THE CITY OF SAN DIEGO
M E M O R A N D U M

DATE: August 16, 2016

SUBJECT: Errata to the Final Program EIR for the San Ysidro Community Plan Update (SCH No. 2015111012, PTS No. 310690)

Impacts to Vegetation Communities and Land Cover Types

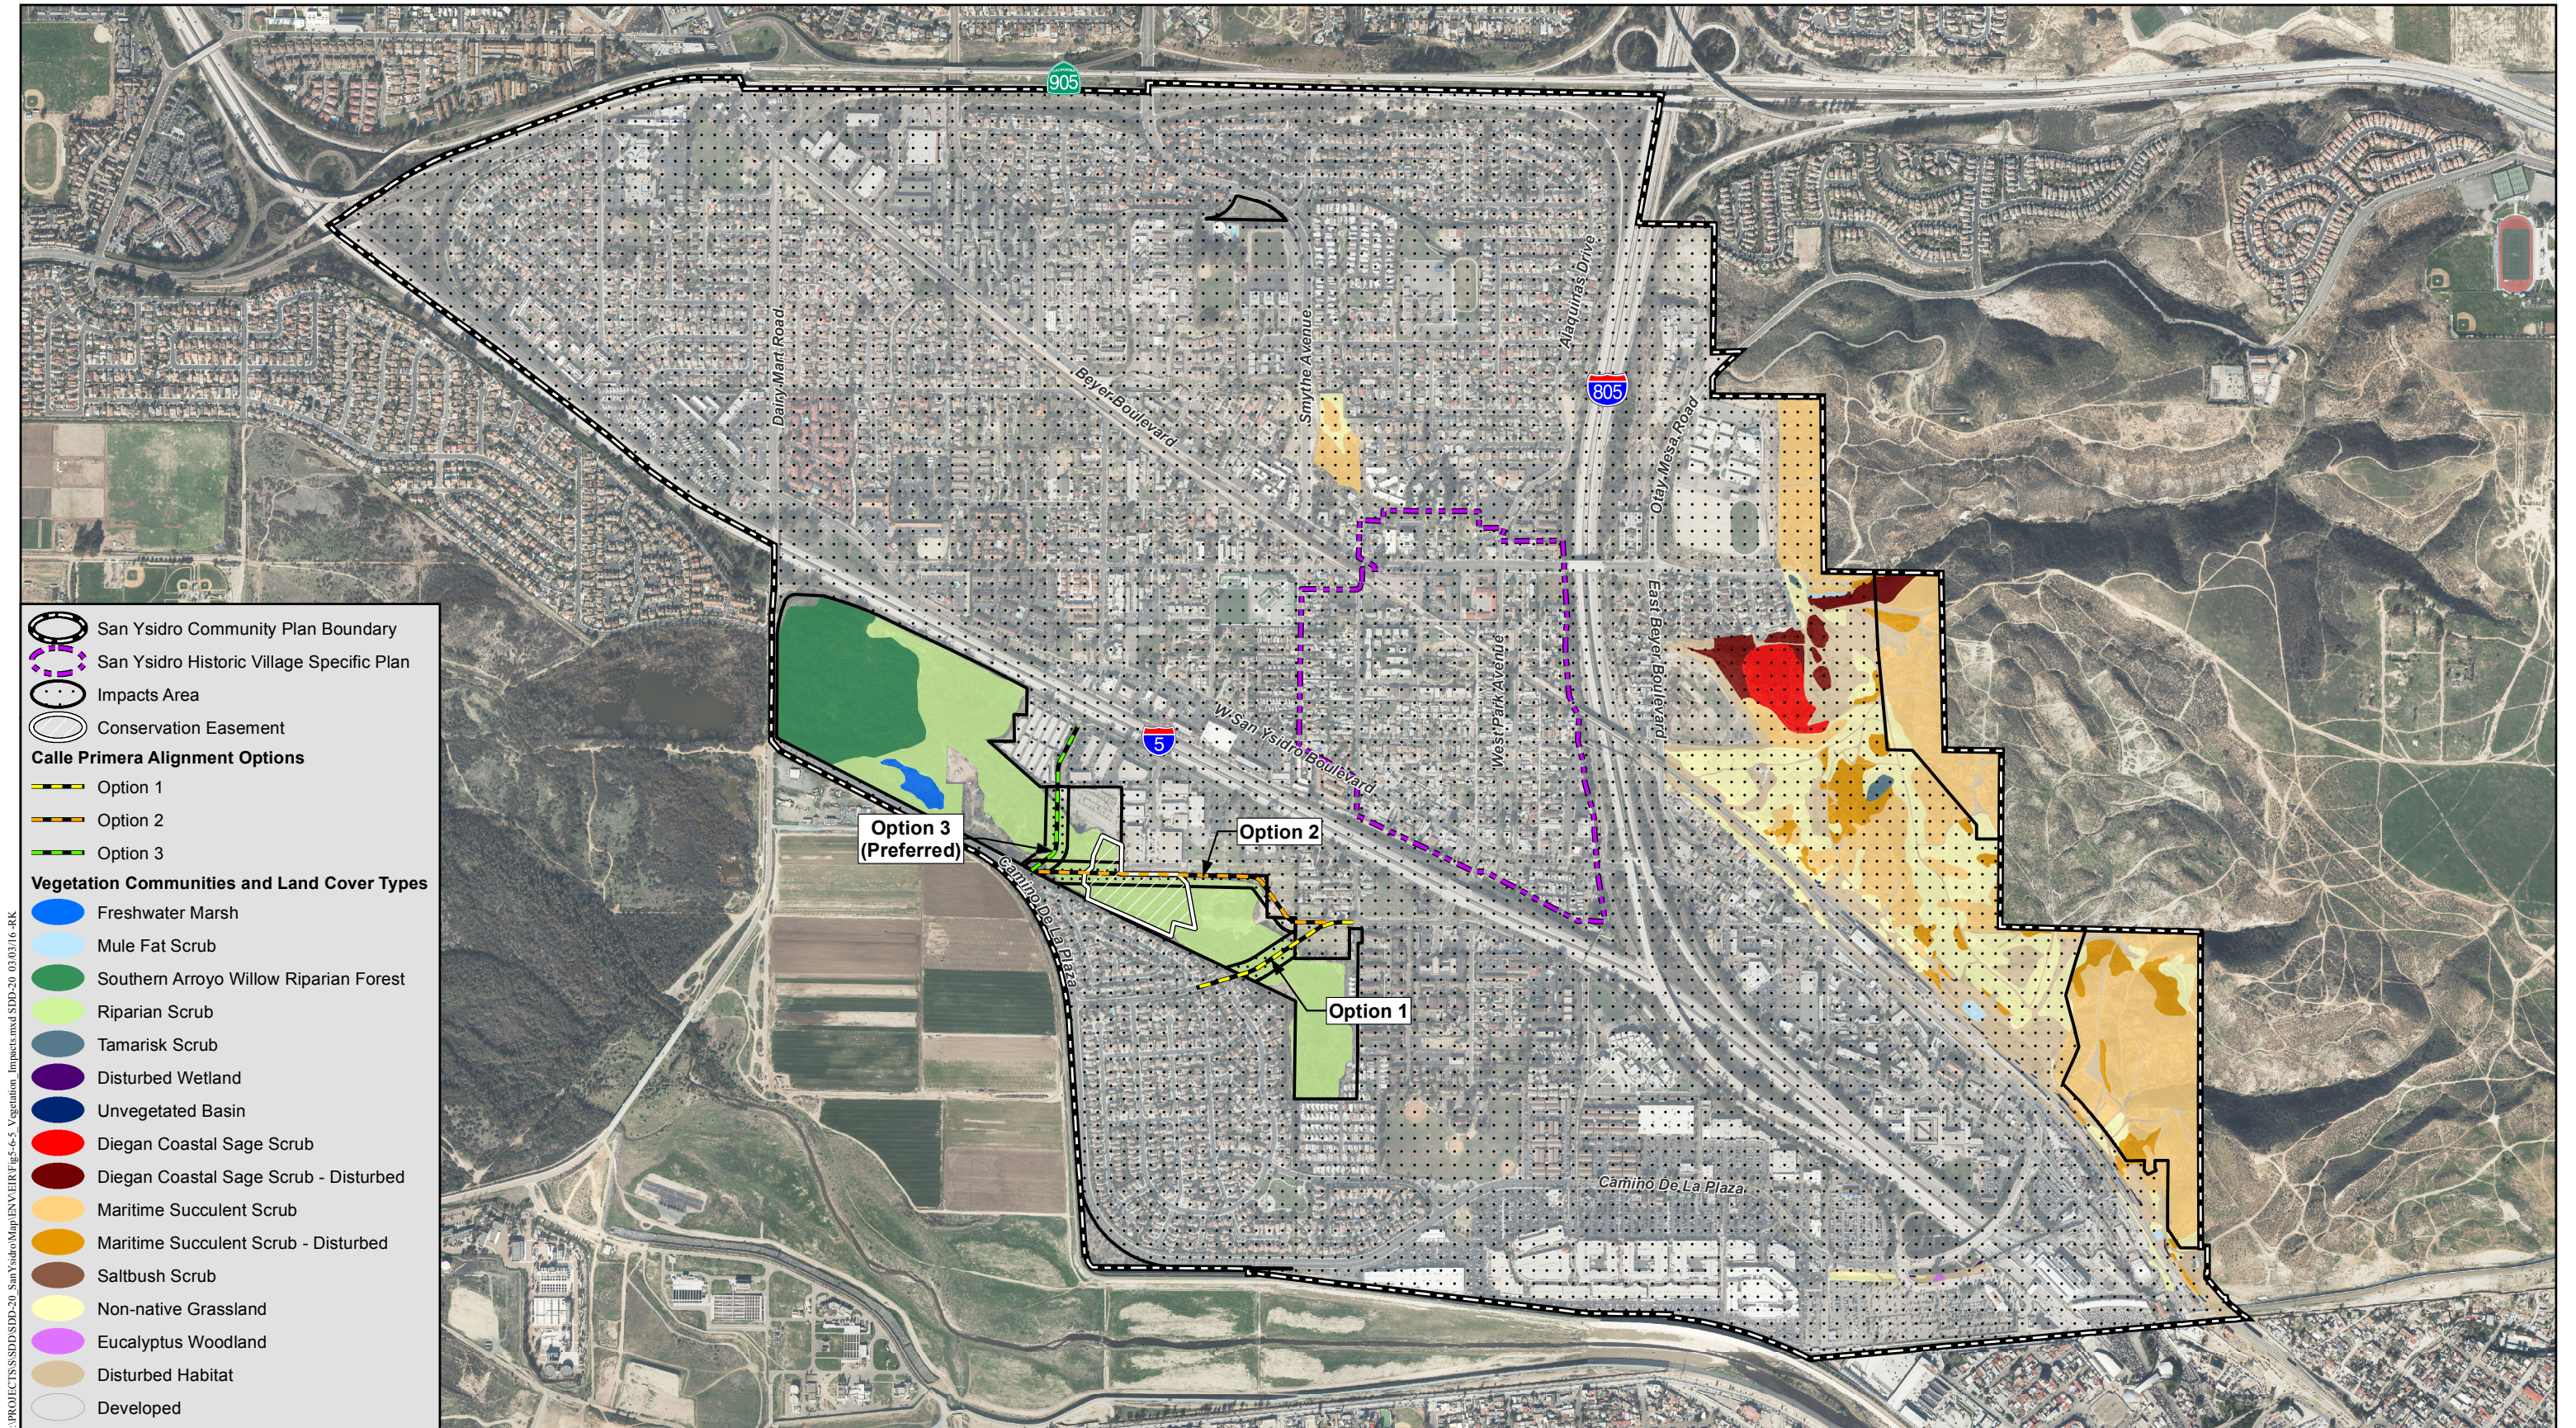
Subsequent to distribution of the Final Program Environmental Impact Report (FEIR) for the above referenced project and in response to comments received from the California Department of Fish and Wildlife (CDFW), Letter A-2 in the Response to Comments, the 7.32-acre United States Army Corps of Engineers (USACE) and CDFW conservation easement for wetland mitigation was added to Figures 5.6-5 and 5.6-6 in the Biological Resources Section (Section 5.6). The easement was also referenced in the Project Description (Chapter 3) and the Biological Resources Section (Section 5.6). The revised pages are attached, and this Errata has been uploaded to the Planning Department's CEQA Policy and Review webpage (<https://www.sandiego.gov/planning/programs/ceqa>).

The proposed extension of Calle Primera also has the potential to impact an existing wetland mitigation area established by the USACE and CDFW. This 7.32-acre conservation easement is located in riparian scrub habitat. As shown in Figure 5.6-5 and 5.6-6, the Calle Primera Option 2 segment would be located within the conservation easement. The Option 1 and preferred Option 3 segment would lie outside the conservation easement and, thus, would avoid impacts to the easement. Additional environmental review would be conducted at the time the extension is proposed to identify actions to reduce impacts, and determine mitigation measures required to avoid or reduce impacts to sensitive biological resources, if approved by the regulatory agencies.
